# Service Bulletin

SXS1000 #3

ISSUED: September 2017

## 2016-2017 SXS1000 Series - Clutch Slipping PRODUCT IMPROVEMENT CAMPAIGN

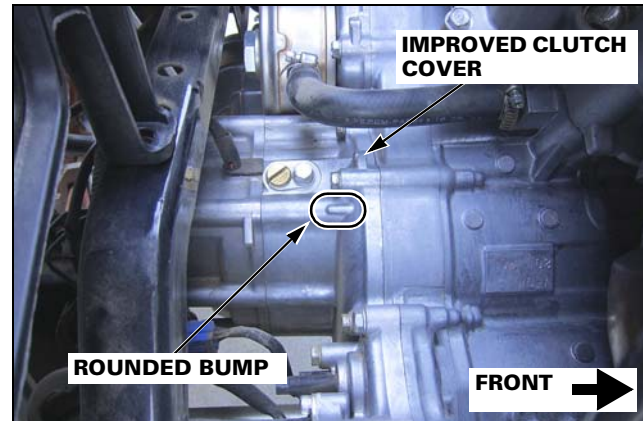
Before you begin the improvement procedure, check if it has already been performed on the unit by looking for the improved clutch cover which can be identified by the rounded bump cast into the cover at the location shown.

- If the improved clutch cover **is installed** – No further action is necessary.
- If the improved clutch cover **is not** installed – You may proceed with the IMPROVEMENT PROCEDURE section of this Service Bulletin.

**CLUTCH CONTROL BODY ASSEMBLY**

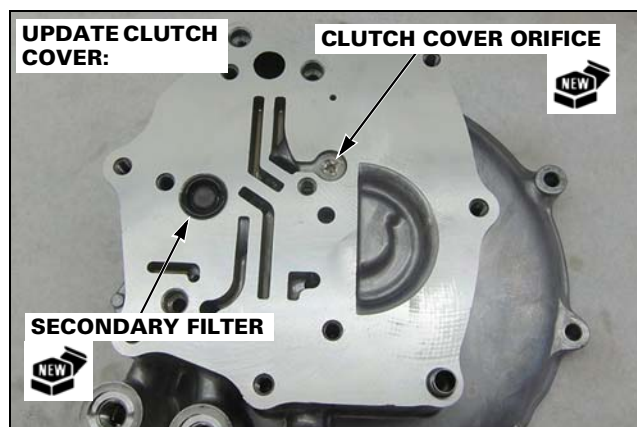
1. Install the update secondary filter into the update clutch cover in the direction shown.

Install the update clutch cover orifice by pushing it into the update clutch cover at the location shown.

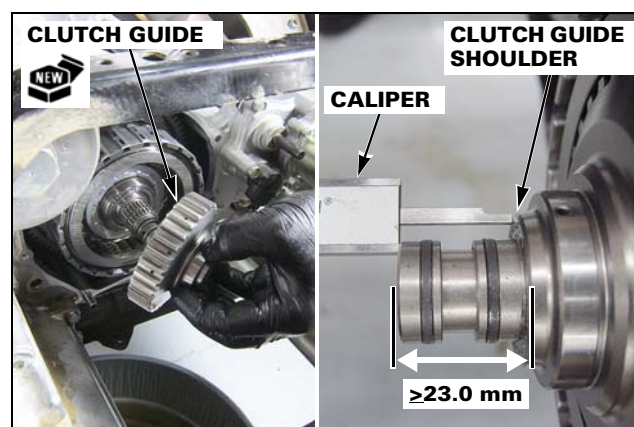
4. Install the SOLENOID COVER to the clutch cover by following the procedure on page 11-46 of the Service Manual.
5. Replace the No. 1 clutch guide with the update part as shown.

Measure the depth of the clutch guide installation between the clutch guide shoulder and end of the mainshaft with a caliper as shown.

**Minimum Depth: 23.0 mm**

If the clutch guide installation depth is less than 23.0 mm, turn the guide back and forth while pushing it in until it seats fully.

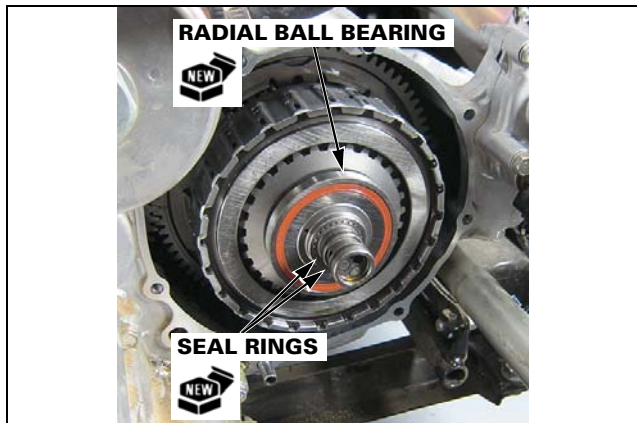
6. Replace the radial ball bearing with the update part as shown.

- The ball bearing seal (orange) should face out as shown.

Install the new seal rings onto the main-shaft as shown.
